UNITED STATES PATENT AND TRADEMARK OFFICE

APPLICATION NO.	FILING DATE	FIRST NAMED INVENTOR	ATTORNEY DOCKET NO.	CONFIRMATION NO.
09/788,420	02/21/2001	Oh Nam Kwon	8733,388.00	5851
30827 7590 08/20/2008 MCKENNA LONG & ALDRIDGE LLP 1900 K STREET, NW WASHINGTON, DC 20006				
EXAMINER RUDE, TIMOTHY L				
ART UNIT 2871		PAPER NUMBER		
MAIL DATE 08/20/2008		DELIVERY MODE PAPER

Office Action Summary

DETAILED ACTION

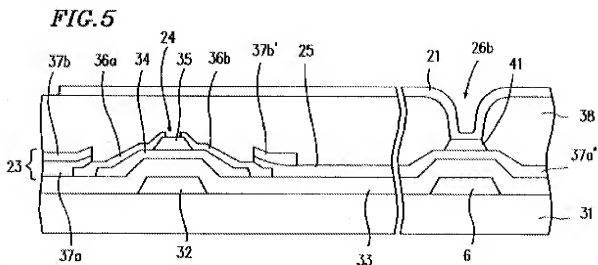
APA does not explicitly disclose an embodiment wherein the sixth conductive layers are exclusively and entirely contained at the bottoms of the first contact hole and the bottom of the contact hole of the first insulating layer.

Tagusa teaches at Figure 5 an embodiment wherein such a metal layer, 41, may be deposited such that it is exclusively and entirely contained at the bottom of a contact hole, 26b, as an art recognized configuration suitable for the intended purpose of improving adhesion of the overlying conductive layer with the underlying conductive layer [col. 12, lines 4-34] which would improve yield and reliability [MPEP 2144.07].

Tagusa is evidence that workers of ordinary skill in the art would find the reason, suggestion, or motivation to form such a metal layer such that it is exclusively and entirely contained at the bottom of a contact hole as an art recognized configuration suitable for the intended purpose of improving adhesion of the overlying conductive layer with the underlying conductive layer [col. 12, lines 4-34] which would improve yield and reliability [MPEP 2144.07].

Therefore, it would have been obvious to one having ordinary skill in the art at the time the invention was made to modify the reflective display invention of APA with the sixth metal layer(s) formed such that it is exclusively and entirely contained at the bottom of a contact hole as an art recognized configuration suitable for the intended purpose of improving adhesion of the overlying conductive layer with the underlying conductive layer [col. 12, lines 4-34] which would improve yield and reliability [MPEP 2144.07].

Tagusa teaches that such a metal layer, 41, may be deposited such that it is exclusively and entirely contained at the bottom of a contact hole, 26b, as an art

recognized configuration suitable for the intended purpose of improving adhesion of the overlying conductive layer with the underlying conductive layer [col. 12, lines 4-34, and Figure 5] which would improve yield and reliability [MPEP 2144.07], per rejections above.
